RE: Letter to Panel addressing issues raised in the Council report and deferral decision

Item LPP02 at 184B, 186 & 190 Kurraba Road, Kurraba Point

This letter has been prepared by Gyde Consulting on behalf of the Applicant, PB & Co in relation to the deferral granted by North Sydney Local Planning Panel (Panel) on 6 December 2023; regarding DA 343/22 at 184b, 186 & 190 Kurraba Road, Kurraba Point (subject site).

COMPLIANCE SUMMARY - R2 ZONE

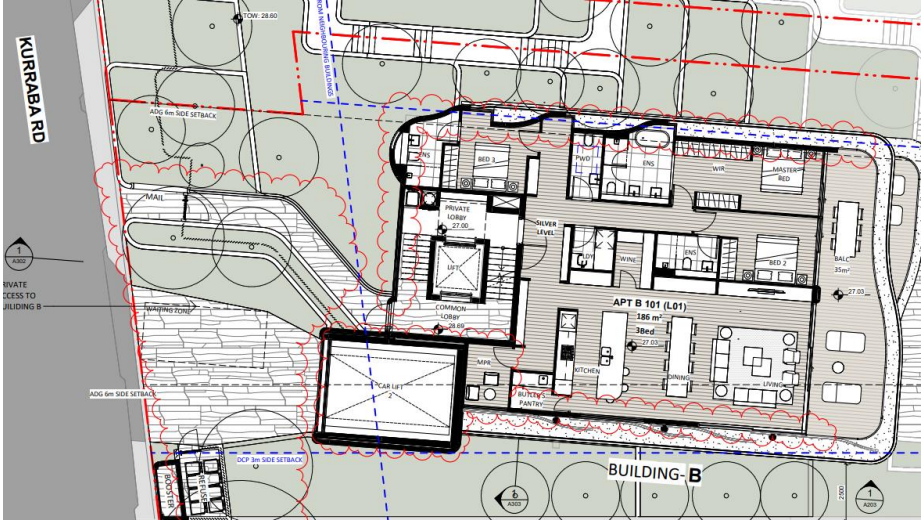
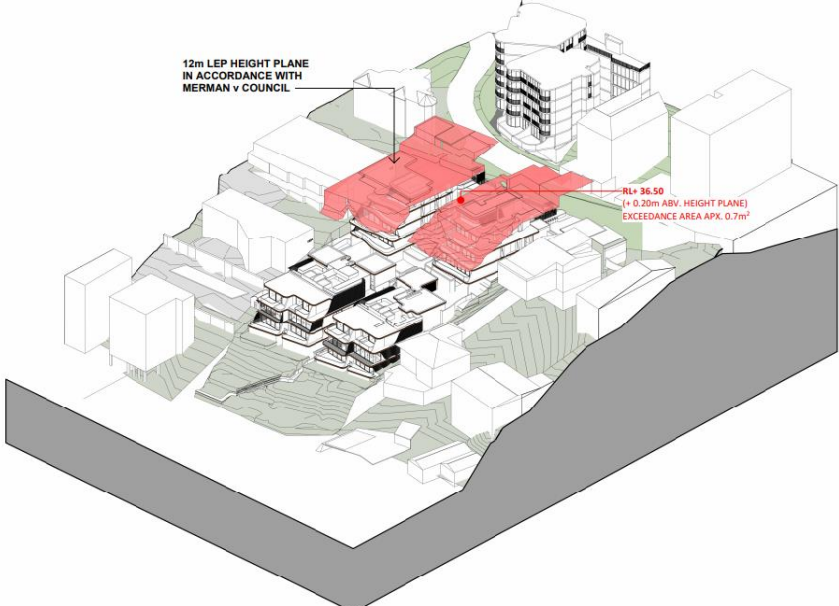
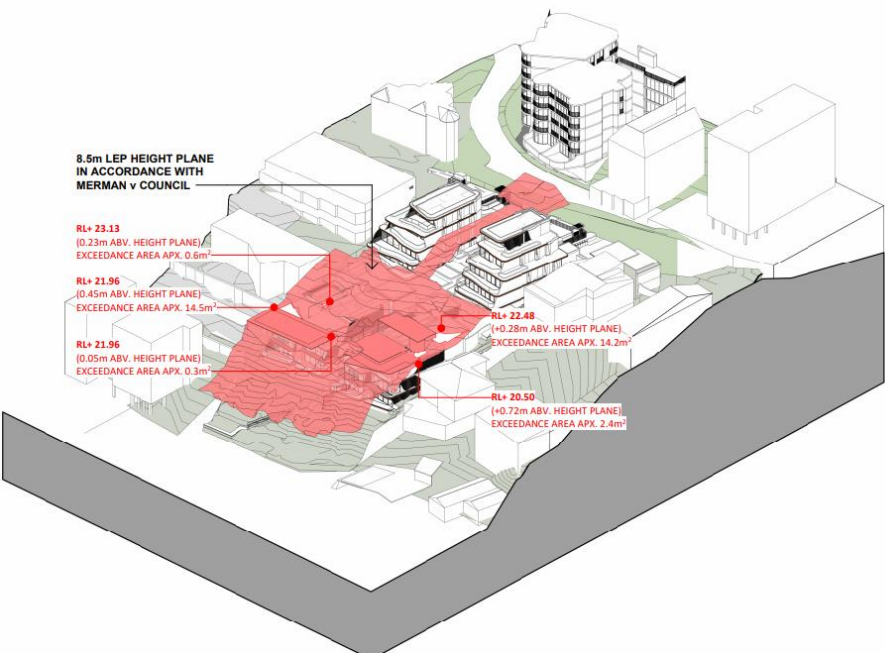
Issues Raised	How the matter has been addressed
<p>1. Site coverage, landscaped area, un-built upon area and desired future character</p>	<p>The Council report states the proposal does not comply with the relevant site coverage requirements for each individual allotment.</p> <p>It was resolved at the Panel meeting dated 6 December 2023 that the site cannot be consolidated as one development as the dual occupancies need to stand on their own allotments in order to be permissible. Therefore, the Panel reasoned that each individual lot must be assessed individually in relation to landscaping and site coverage.</p> <p>As such, drawing A401(Rev 7) shows the site coverage, landscaped area and un-built upon areas for each individual lot, refer to extract below.</p>

PROPOSED R2 NORTH	PROPOSED R2 SOUTH	COMBINED R2	R2 CONTROL
SITE COVERAGE	400.1m ² = 43.3%	430.0m ² =42.5%	830.1m²=42.9%	North: Max 45% = 416m ² South: Max 45% = 455m ²
LANDSCAPE	421.8m ² = 45.7%	434.3m ² =42.9%	856.1m²=44.2%	North: Min Total Landscape 40% = 370m ² South: Min Total Landscape 40% = 405m ²
UNBUILT UPON AREA	102.1m ² = 11%	147.7m ² =14.6%	249.8m² = 12.9%	North: Max 15% = 139m ² South: Max 15% = 152m ²
SITE AREA	924 m ²	1012 m ²	1936 m²

The individual lots of the proposal, as amended, largely comply with the development controls, in particular landscaping and site coverage. The proposal results in a minor non-compliance of 0.8% over the maximum for the R4 north site in the R4 Zone un-built upon area, however this is offset by the R4 south site which achieves max 14.6% un-built upon land; thus, the proposal almost achieves compliance for the total R4 zoned land, with a minor 0.2% over provision. It should be noted that the recent approval of the neighbouring property 184 Kurraba Road at the NSLPP meeting dated 06/12/23 was approved with a 0.2% under provision on landscaping provision, which is not too dissimilar from the minor 0.2% over provision of un-built upon area in this application. This minor non-compliance for the north site will be negligible when viewed from the public and private domains, especially since the southern site provides less than what is permitted. Other than this the proposal, as individual lots, strictly comply with the Council DCP provisions and objectives of these controls, and therefore this matter has been addressed. This results in the buildings' appearance being consistent with the requirements of bulk and scale expected for the immediate area under the provisions of the North Sydney DCP 2013 in relation to built form character, form, massing and scale.

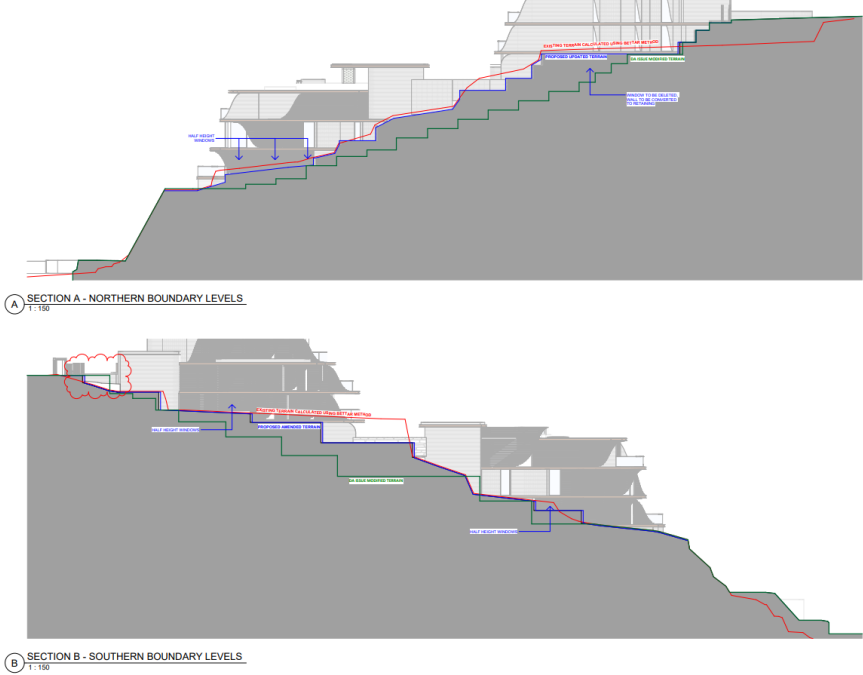
The plans submitted with the RFI package has deducted the built form on the ground as required by Council, including that located within the Foreshore Area. It has not deducted the overhead slabs of elevated levels, as landscaping is still achieved below these. Also, it has excluded the existing ROW for the site to the north.

The existing access handles for the R2 zoned land have been included as the development site encompasses all 4 titles as one integrated development.

Issues Raised	How the matter has been addressed
	 <p data-bbox="534 1019 853 1064">R4 HEIGHT PLANE DIAGRAM - 12m ABOVE EXISTING GROUND LEVEL (VIEW 1)</p>
	 <p data-bbox="526 1892 869 1937">R2 HEIGHT PLANE DIAGRAM - 8.5m ABOVE EXISTING GROUND LEVEL (VIEW 1)</p>

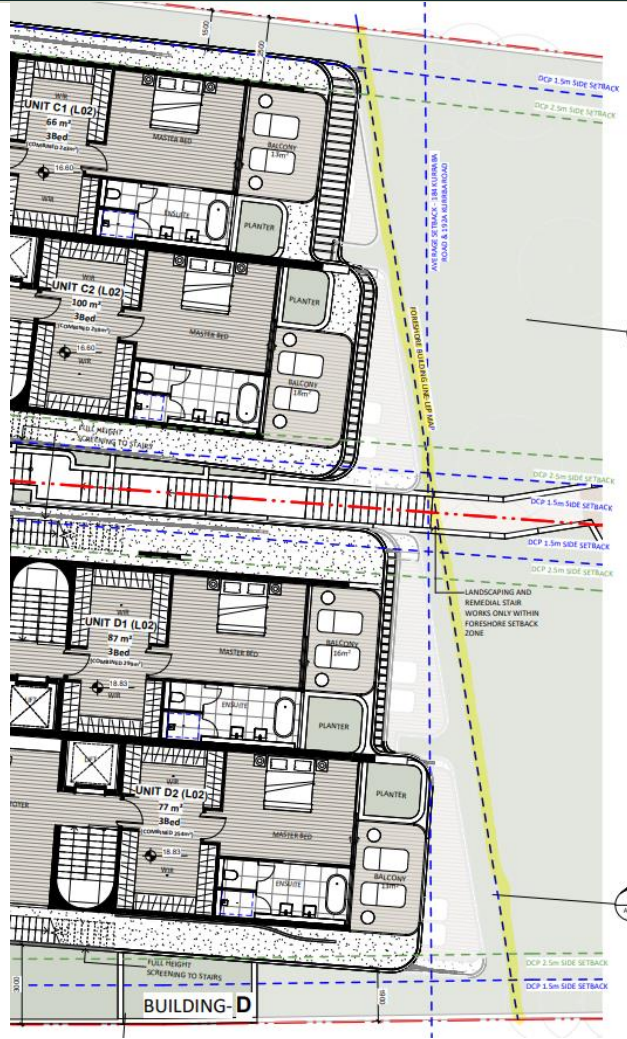
Issues Raised	How the matter has been addressed
	<p>They do not operate as a typical “battle-axe” handle within the integrated development, and as such should be included in the site area calculation. Therefore, it is considered that this matter has been addressed.</p>
<p>2. On-street waiting bay serving Buildings B and D</p>	<p>Council and the Panel’s concern regarding the on-street waiting zone adjacent to Building B is acknowledged. In consideration of this the design has been amended to integrate the car lift into Building B to make room for an off-street waiting zone. Refer to attached drawings A104 and A105. An extract is included below which shows the amended design.</p>  <p>It is therefore considered that this matter has been addressed through the amended design of Building B.</p>
<p>3. Building Height</p>	<p>The original application submitted to Council calculated the height based on the Merman principles, including the Clause 4.6.</p> <p>Council’s RFI dated 15 August 2023, requested the applicant “to provide a 3D height blanket diagram as measured from the extrapolated topography in accordance with <i>Bettar v Council of the City of Sydney</i> [2014] NSWLEC 1070”.</p> <p>The amended plans submitted with the RFI reduced the physical height of the buildings, stepped the buildings away from the side boundaries, and provided a revised height blanket diagram based on Bettar, as requested by Council, refer to sheet A110. Consequently, the Clause 4.6 had to be amended to reflect the Bettar calculations. This was provided as part of the RFI package.</p> <p>A diagram showing the survey points which were used to generate the height blanket was provided, refer to sheet A630. The applicant believes the amended plans submitted with the RFI package were addressing Council’s requests. After review of the Council report, revised diagrams have been prepared demonstrating the height blankets based on Merman for the revised scheme. (Refer to drawings A481 and A483). As can be seen with this, the height variation is minimal with:</p> <ul style="list-style-type: none"> - The R4 zoned land exceeding the 12m height by 0.2m (RL36.5) - The R2 zoned land exceeding the 8.5m height limit by 0.05m (RL21.96) – max 0.72m (RL20.5). Refer to extract below.

Issues Raised	How the matter has been addressed
	<p>The Clause 4.6 has subsequently been updated to reflect the amended design changes and also the calculation based on Merman, not Bettar. This is attached with this letter.</p> <p>Council’s report on page 35 states “...the non-compliances with building height are relatively minor and are generally acceptable”.</p> <p>We believe this issue has now been resolved.</p>
<p>4. Heritage (the proposal does not address the associative significance relating to Trygve Halvorsen)</p>	<p>The site is not identified as a heritage item nor within a heritage conservation area.</p> <p>A revised Heritage Impact Statement (HIS) dated 22 August 2022 prepared by Urbis, was submitted as part of the RFI package to Council. Page 6, 10 and 11 of that report discusses the Associative Significance of the Trygve Halvorsen house and that it has been heavily modified and limited associate remains. Halvorsen previously lived at 186 Kurraba Road before selling in c. 1960. The house was heavily modified as part of 1970s, 1980s and 2005.</p> <p><i>“...significant alterations and additions were undertaken to the dwelling during the 1960s and 70s which involved the removal of original features including flooring, cornices, skirting, corbels, and ceiling roses. It is understood that these works removed the original interior and established a contemporary interior, now reflecting the 1970s rather than Halvorsen’s time of residence in the 1940s. Similar interior works were carried out again in the 1980s and in following decades. The significant amount of works undertaken to the dwelling have removed any personal inflection that Halvorsen may have incorporated to his former home.”</i></p> <p><i>“Further, the exterior of the house is also highly modified and whilst it maintains some elements of the Inter-War Functionalist architectural style, it maintains little integrity overall. The subject dwelling does not hold aesthetic significance as an example of Inter-War architecture on its own merit, nor has it been encapsulated by a greater heritage conservation area to date. Halvorsen did not commission any known architect to construct his home and whilst the extent to which Halvorsen’s personal taste influenced the style of the house is unknown, it is clear that the alterations and additions undertaken by later owners have diminished the original design intent. The existing condition of the dwelling, both internally and externally, does not demonstrate a continued, tangible link between the property and Halvorsen.”</i></p> <p>This HIS concludes that in relation to Associative Significance, “The subject site does not reach the threshold of local significance under this criterion.”</p> <p>In response to Council’s report further heritage advice has been received which states:</p> <p><i>“Further, the subject site does not feature moveable heritage or landscape features such as a jetty or wharf which demonstrate tangible association with Halvorsen or sailing. Furthermore, while well known in the sailing community, there is little information to suggest that Halvorsen was a well-known figure within the North Sydney LGA who contributed to the LGA’s history. The subject site does not reach the threshold of associative significance at a local level and does not warrant retention.</i></p> <p><i>Interpretation of Halvorsen’s occupation of the place may be suitably demonstrated through the implementation of a short sign or plaque within the</i></p>
